Staff Report  
Plan Commission Meeting – December 5, 2023

| <b>Application:</b>        | Final Plat of Subdivision (Minor Subdivision)              |

**Cityview Resubdivison**

# CITYVIEW'S FIRST RESUBDIVISION

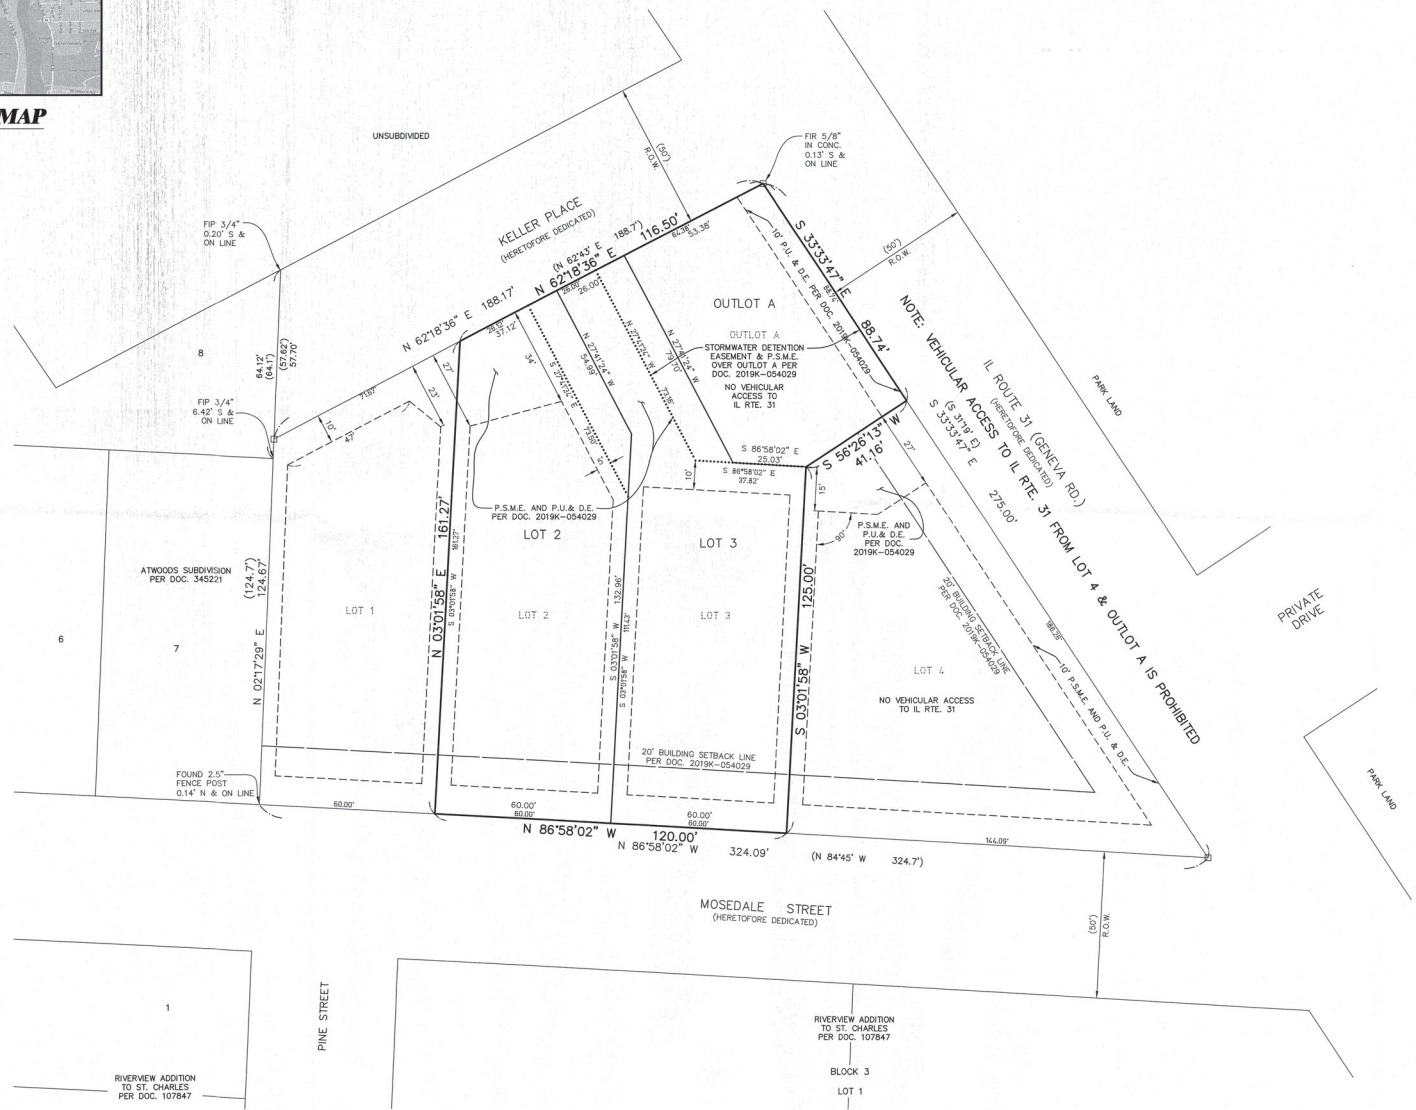
Staff is recommending the outlot be increased on the south to encompass the entirety of the stormwater management facility. The previous Plat of Subdivision allowed these areas in easements. Staff believes this change will more clearly define the restrictions over the stormwater management areas. (See Engineering comments section)

- ✓ Stormwater Detention Easement and PSME over Outlot A - reduce the westerly limits of the easement to match the new boundary of Outlot A.
- ✓ PSME & PUDE – extend the limits of the easement to the east to match the new boundary of Outlot A.
- ✓ Outlot A – move the lot line south and southeasterly such that the entire limits of the High Water Line is located within Outlot A. This will affect rear lot lines for Lots 3 and 4.
- ✓ Add the HWL contour line to the plans. Label the elevation.
- ✓ Revise lot lines and easements per Plat comments.
- ✓ Revise building footprint on Lot 4 to accommodate Plat comment #3. Please note the rear lot line setback is 30-feet.
- ✓ Assuming the rock wall is the responsibility of Lot 3 property owner, it shall be located entirely on Lot 3. Confirm with new lot line configuration.

### OVERALL UTILITY PLAN

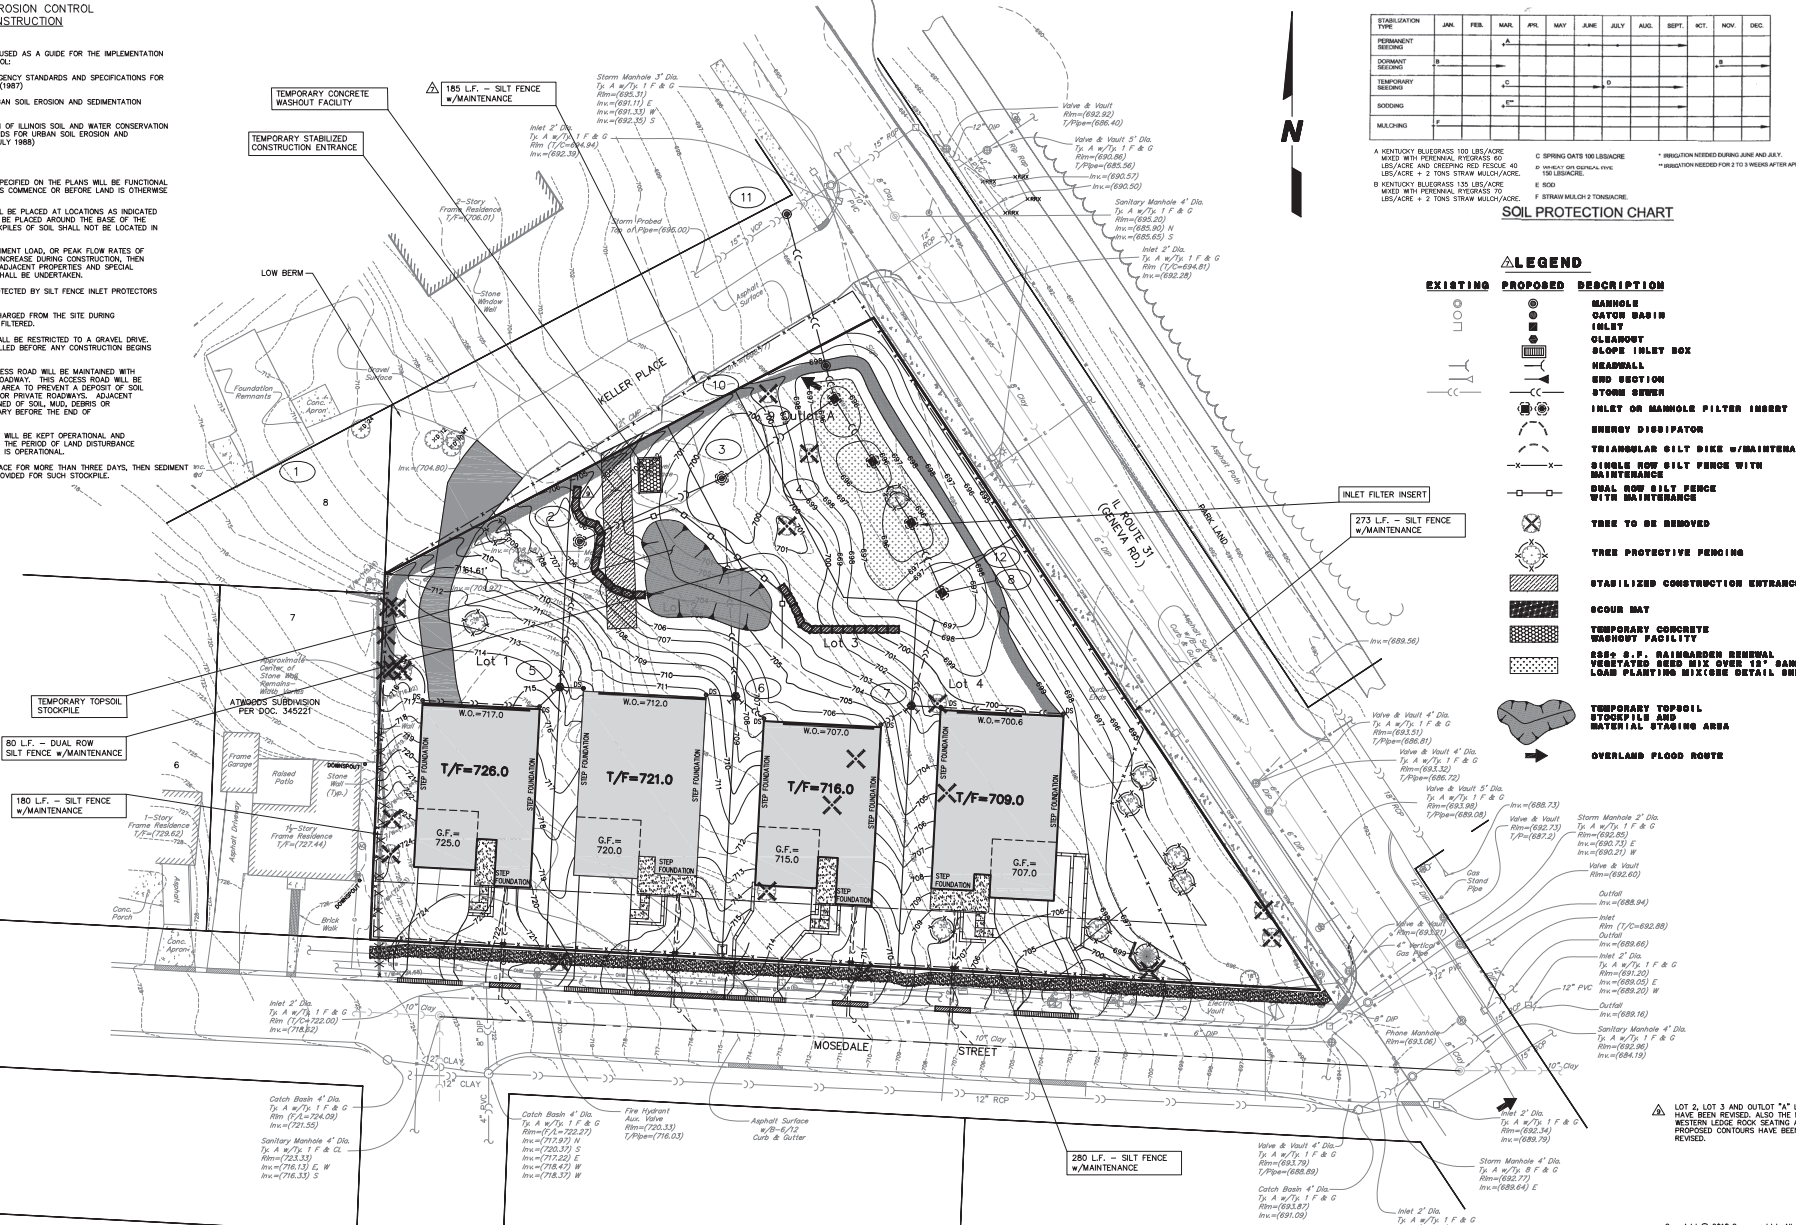
▲ LOT 2, LOT 3 AND OUTLOT A LINES HAVE BEEN REVISED ALSO NORTH WESTERN LEDGE ROCK SEATING.

DRAINAGE AND GRADING PLAN  
CITYVIEW SUBDIVISION

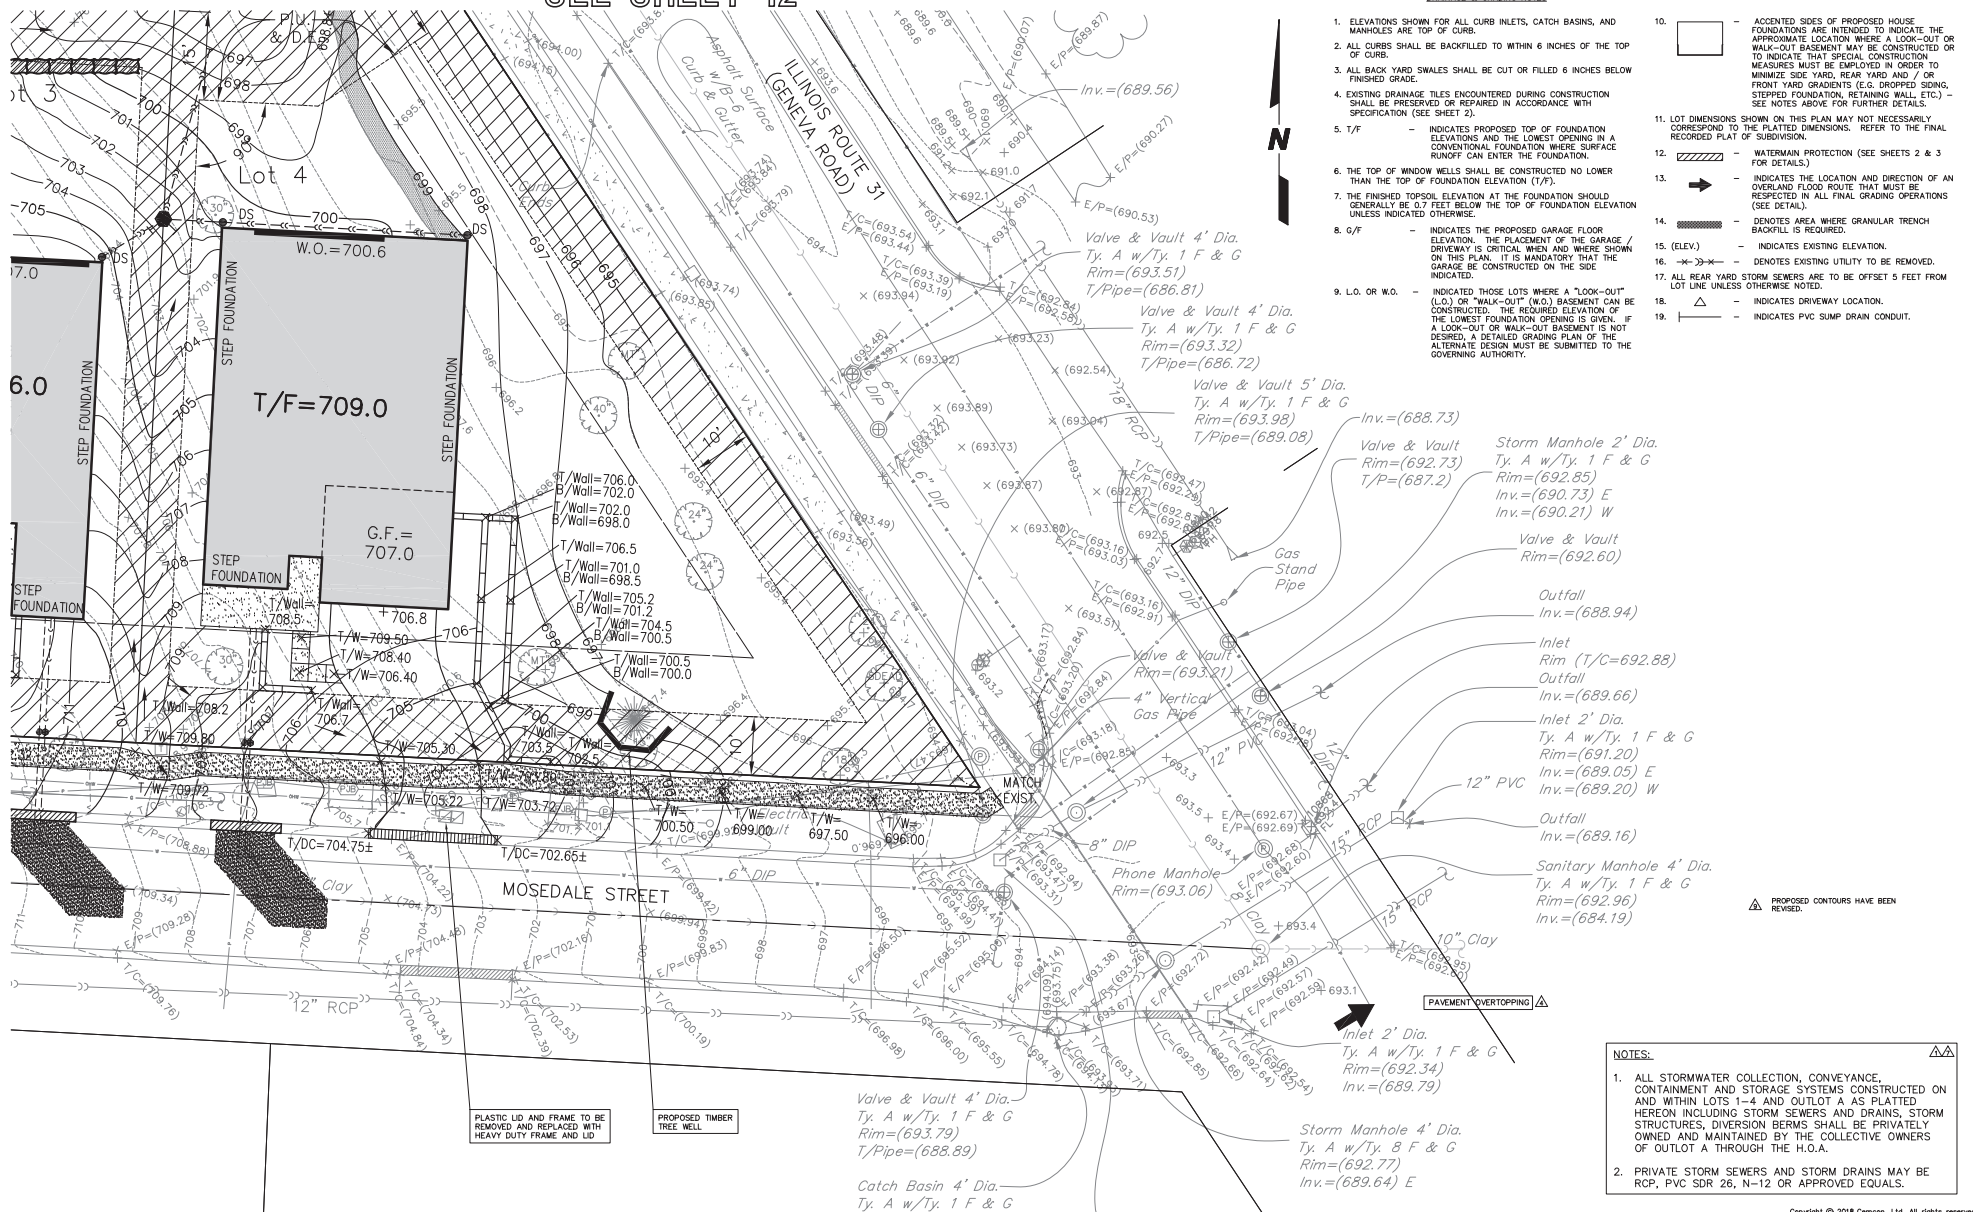
PROPOSED CONTOURS HAVE BEEN REVISED.
